Re: Second Submission Review – King's Point CSP No 1
Application Number: **DA-1609-16**
Case Number: **2016-4012-00**

*Second Submission Review***SUMMARY OF KEY COMMENTS FROM ALL DEPARTMENTS**

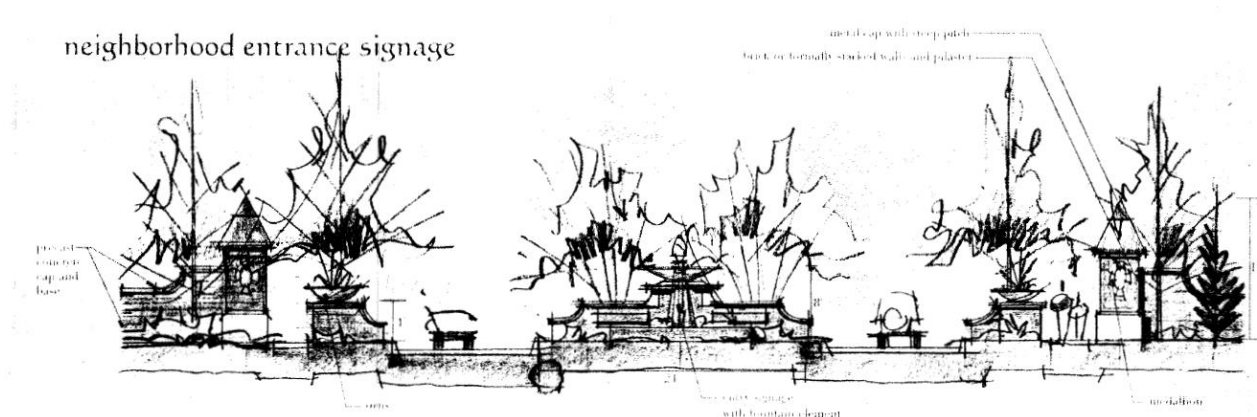
3A. CDOT has provided comment regarding Aurora Parkway. Please continue to work with Victor Rachel and Rick Solomon regarding these comments.
